## ADDENDUM #1

Reference: Building 5100 – Camp Williams  
Utah National Guard – Riverton, Utah  
DFCM Project No. 07332480

addendum  
# 1

DFCM Project #:07332480  
ajc architects project #: 0781

**SD1.1**

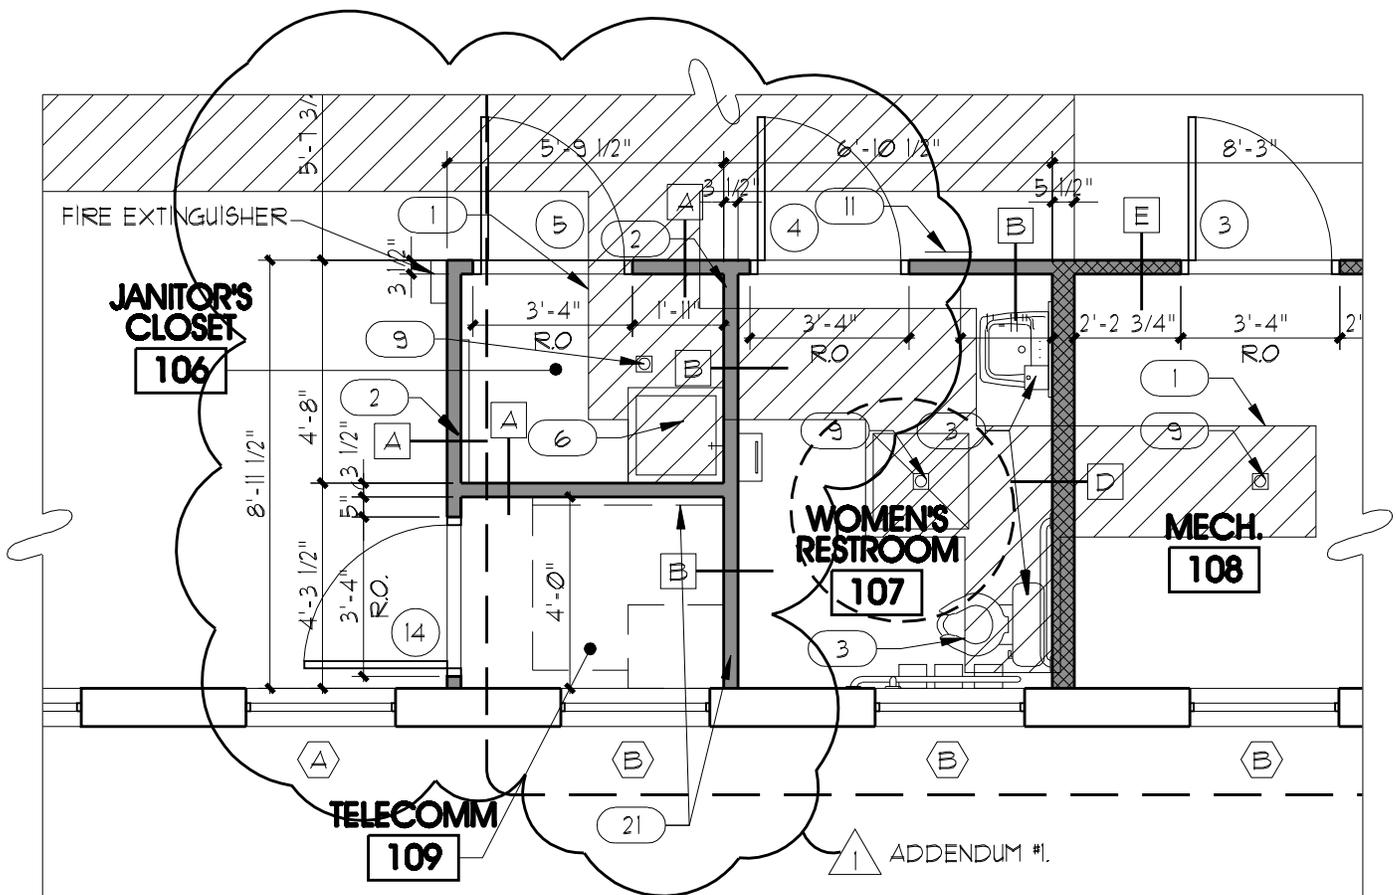
- Item #1.7 Specification Section 09960 – HIGH PERFORMANCE COATINGS, Part 2.4, A., add “At Painted Toilet Room and Kitchen Walls”.
- Item #1.8 Architectural Site Plan A6/AS101, sheet AS101. The street cut for the sewer line extension has been deleted. Refer to revised partial site plan Supplemental Drawing, SD1.1 for extent of sewer line excavation and existing sewer line tie-in point, applicable to both Building 5100 and 5080. EXISTING / DEMO KEYED NOTE LEGEND: delete Keyed Note 4. “Existing Maintenance Hole to be Abandoned as part of Alternate #1 Building 5080. See Cover Sheet for Summary of Work.”

SD1.2

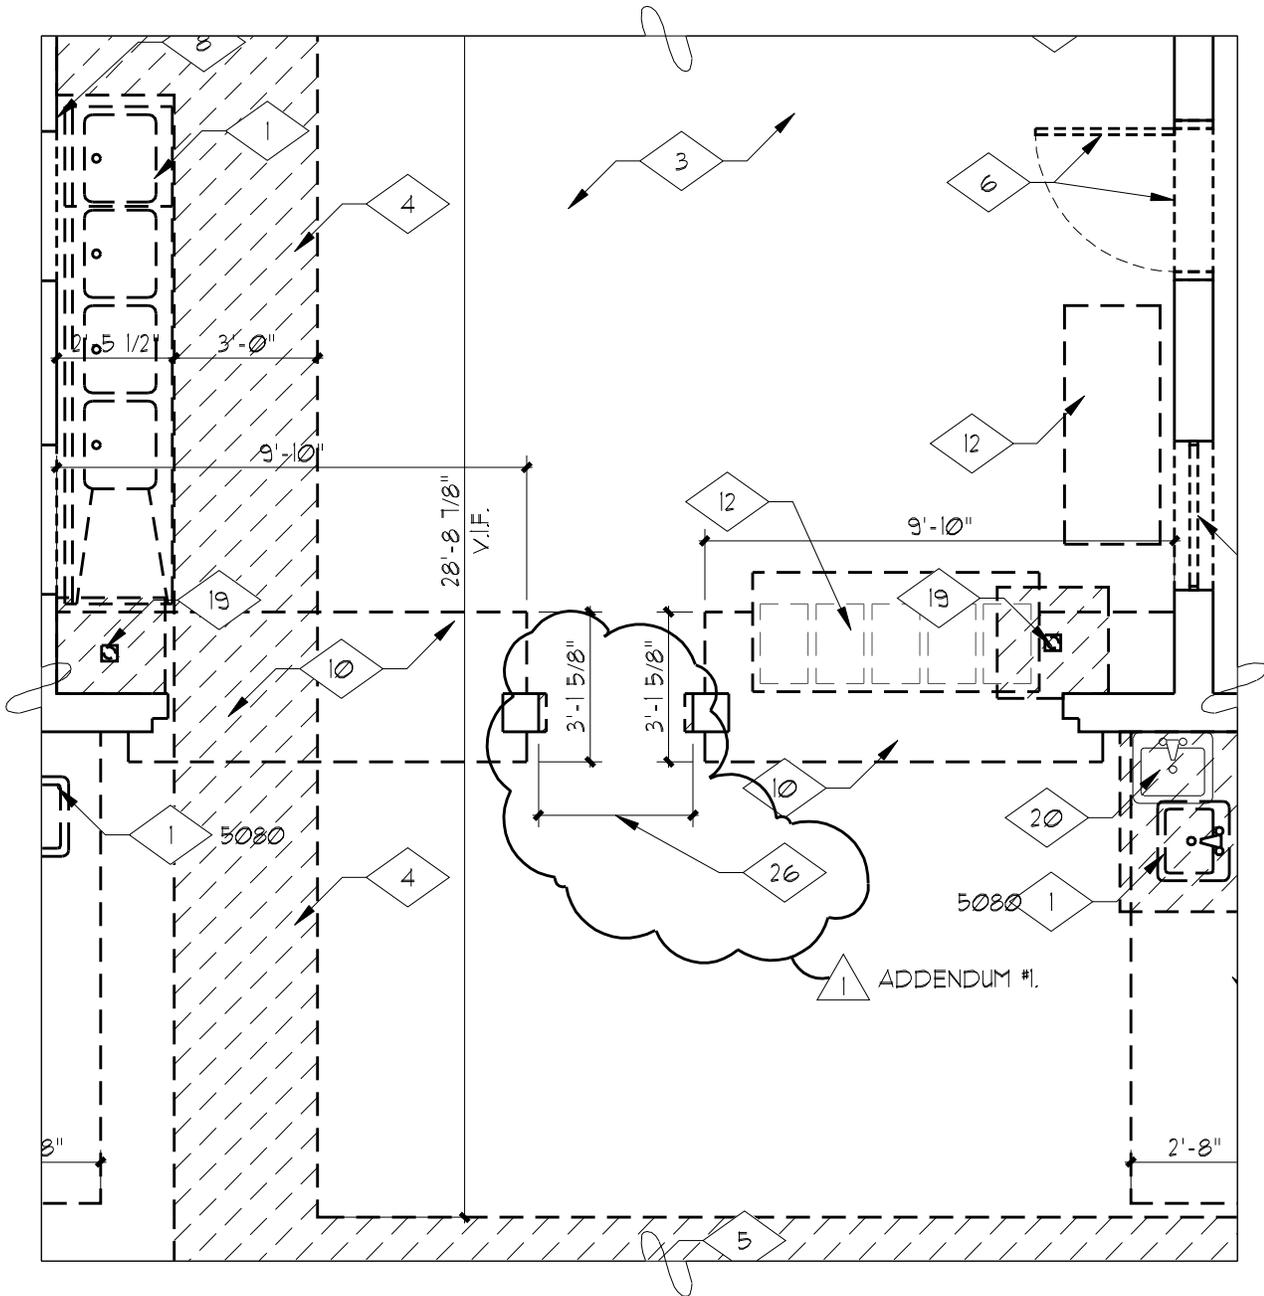
- Item #1.9 New Construction Floor Plan A5/AE101, sheet AE101. The Women’s Toilet Room 107 has been enlarged to provide ADA access. Refer to revised partial Floor Plan, Supplemental Drawing, SD1.2. The opening for Door #10 has been widened for ADA access. Refer to Supplemental Drawings SD1.3, SD1.4 and SD1.6. The sidewalk cut and replacement for new utility line has been revised. Refer to partial Floor Plan, Supplemental Drawing SD1.8. These changes are applicable to both Building 5100 and 5080.

SD1.3

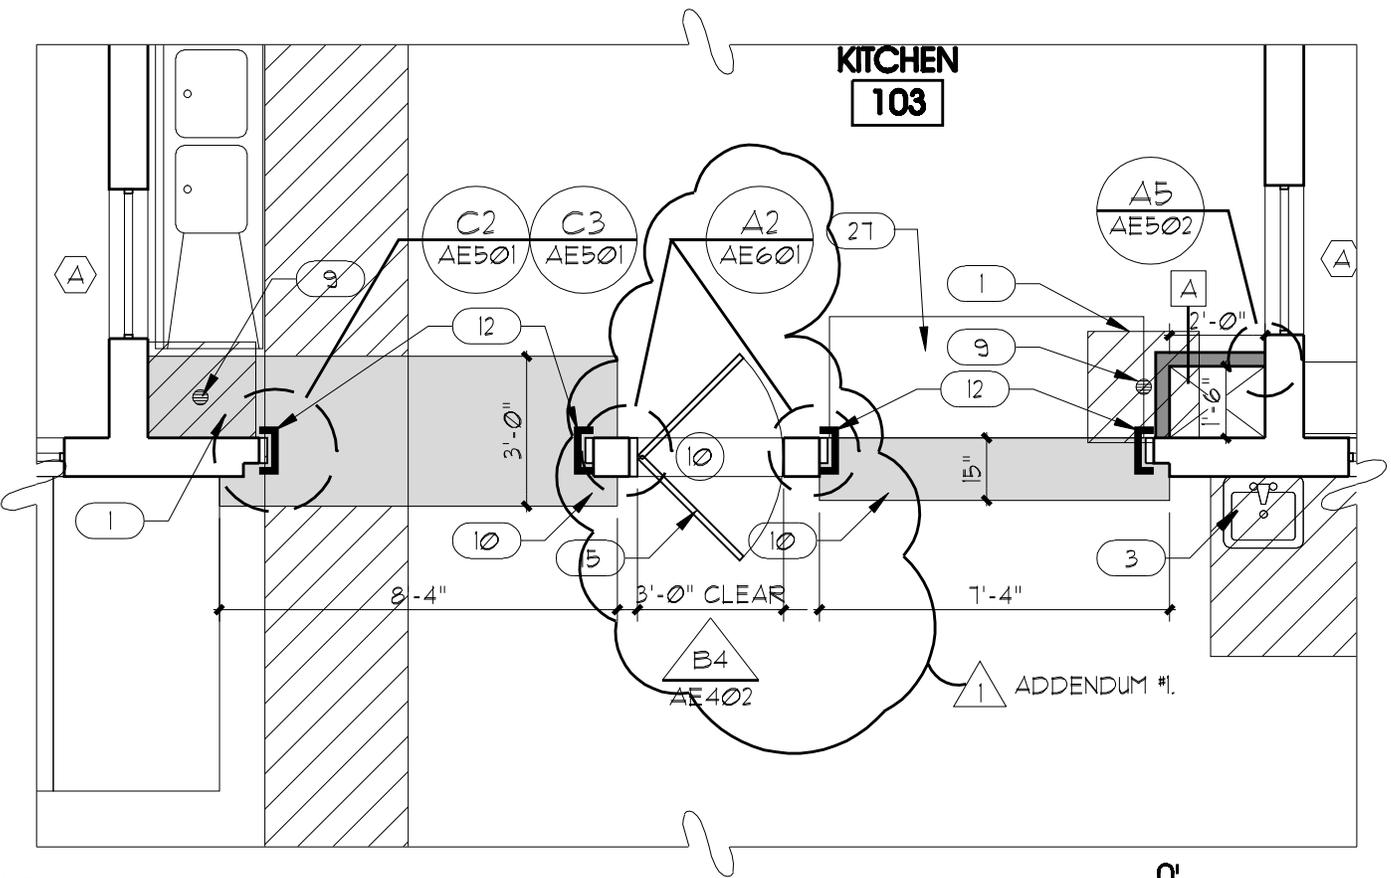
- Item #1.10 Demolition Floor Plan A5/AD101. The existing masonry opening at the kitchen impact door (#10) has been widened for ADA accessibility. Refer to partial Demolition Floor Plan, Supplemental Drawing SD1.3.

26 SAW CUT & REMOVE EXISTING MASONRY AS REQUIRED FOR NEW DOOR & FRAME. VERIFY REQUIRED OPENING SIZE WITH SELECTED DOOR & FRAME. REMOVE WOOD DOOR FRAME IN BUILDING 5100 PRIOR TO MODIFYING MASONRY OPENING.

**SD1.5**

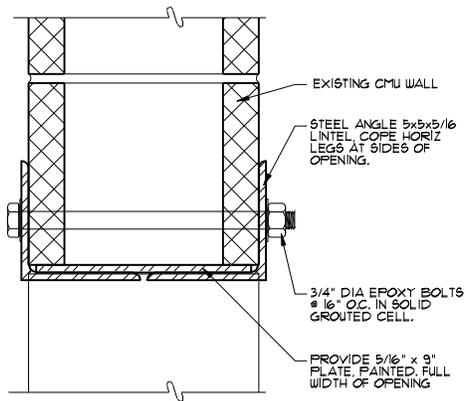
- Item #1.13 Detail Sheet AE502. Grease Exhaust Fan Detail B5/AE502 has been revised. Refer to Supplemental Drawing SD1.5.

SD1.6

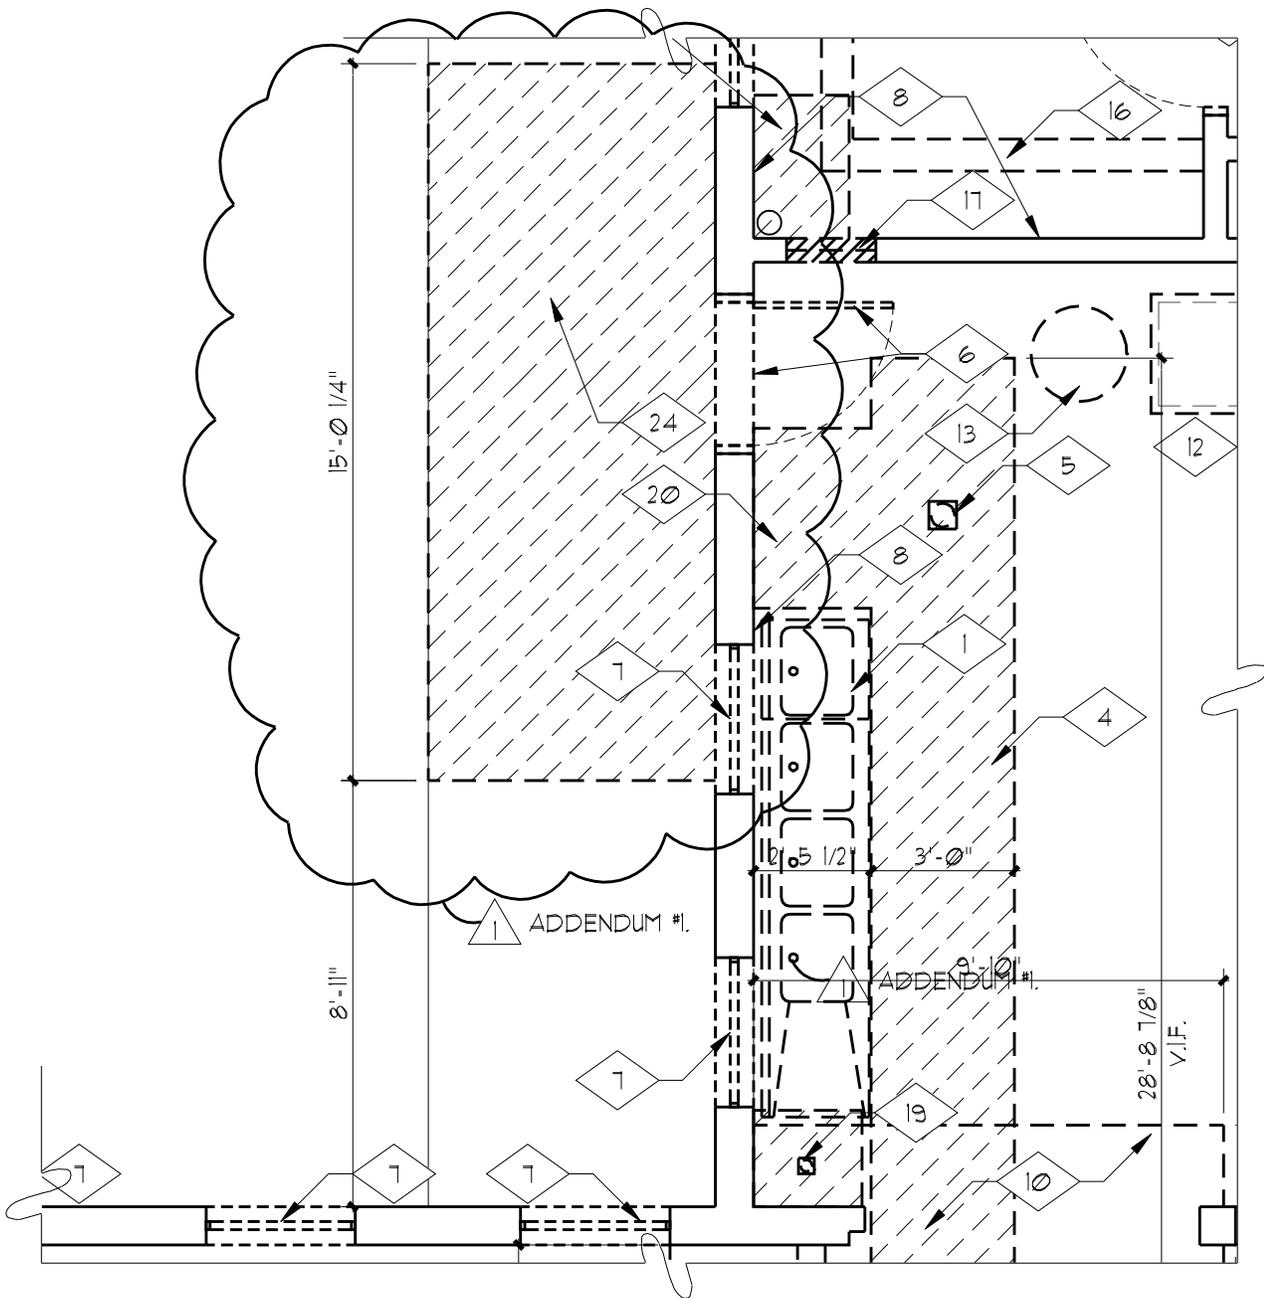
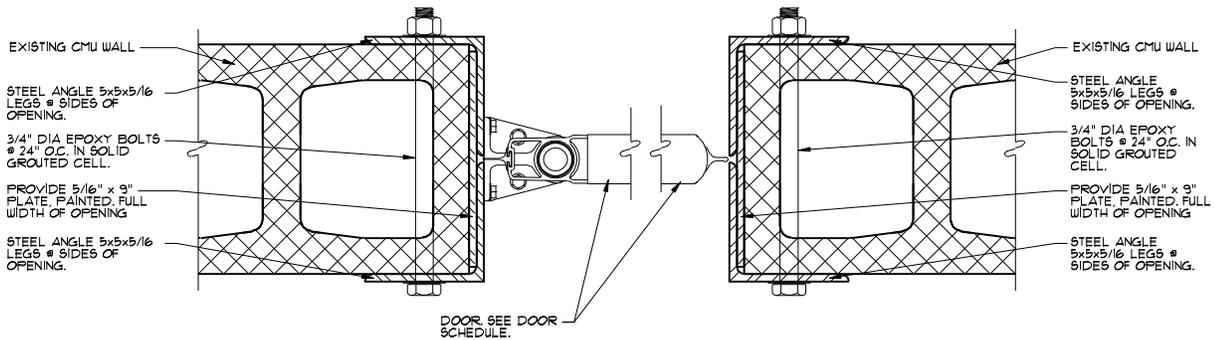
- Item #1.14 | Sheet AE601. The exterior entry doors for Building 5100 have been revised. On the DOOR SCHEDULE, change doors #1, 2, 7, 8, 9, and 12 to Door Type "D". Refer to Supplemental Drawing SD1.6. Refer to photo of existing exterior wood doors for replacement door go-by. Exterior doors for Building 5080 may remain as scheduled. DOOR TYPES, add Door Type "D", refer to Supplemental Drawing SD1.9. Door Type C, change detail references to B2/AE601 and A2/AE601. Refer to Supplemental Drawing SD1.11. WINDOW TYPES, change Window Type A, BUILDING 5100 note to read "ALUMINUM WITH EXTERIOR MUNTIN BARS". Change Window Type B, BUILDING 5100 note to read "ALUMINUM WITH EXTERIOR MUNTIN BARS". Refer to attached photo of existing windows for historic window replacement go-by. Change, Building 5100 steel windows note to read: "NOTE: IF ALUMINUM WINDOWS WITH EXTERIOR MUNTIN BARS ARE NOT ABLE TO BE PROVIDED FOR BUILDING 5100, FURNISH AND INSTALL STEEL WINDOWS EQUAL TO HOPE'S, JAMESTOWN 175 SERIES. PREFINISHED SINGLE HUNG, SIX OVER SIX, STEEL WINDOWS WITH LOW E INSULATED GLASS AND EXTERIOR SIDE MUNTIN GRIDS."

**SD1.10**

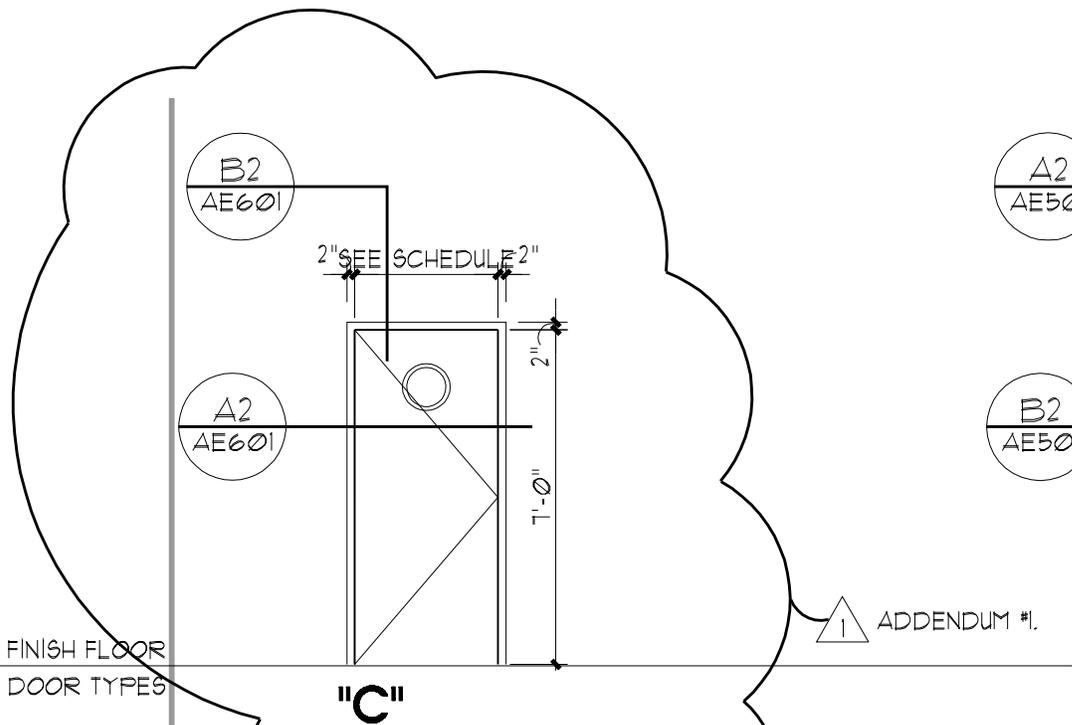
- Item #1.11 New Construction Reflected Ceiling Plan A5/AE102. The reflected ceiling plan has been revised to show the enlarged Women’s Toilet Room 107. Refer to partial Ceiling Plan, Supplemental Drawing SD1.10. This change is applicable to both Building 5100 and 5080.

**SUPPLEMENTAL DRAWING SD1.11**

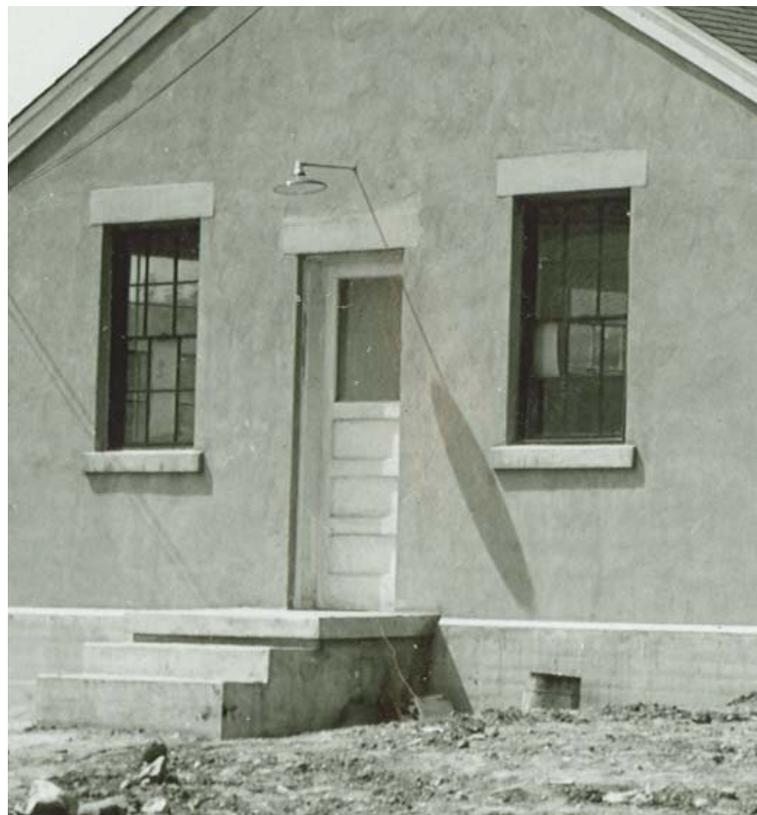
DOUBLE ACTION IMPACT DOOR: ELIASON, (OR APPROVED EQ.) MODEL HCP 10, HIGH IMPACT DOORS, W/ 1-1/2" POLYMER CELL CORE DOORS W/ .125" THERMOPLASTIC EXTERIOR SURFACE BONDED TO A HIGH STRENGTH STRUCTURAL FRAME, 17-3/8" H. FACTORY INSTALLED SCUFF PLATES EACH SIDE, 10" ROUND CLEAR ACRYLIC (DOUBLE GLAZED) WINDOWS SET IN BLACK RUBBER MOLDING, HIGH IMPACT GASKET RETAINER IN EXTERIOR FRAME COLOR - BLACK 108.
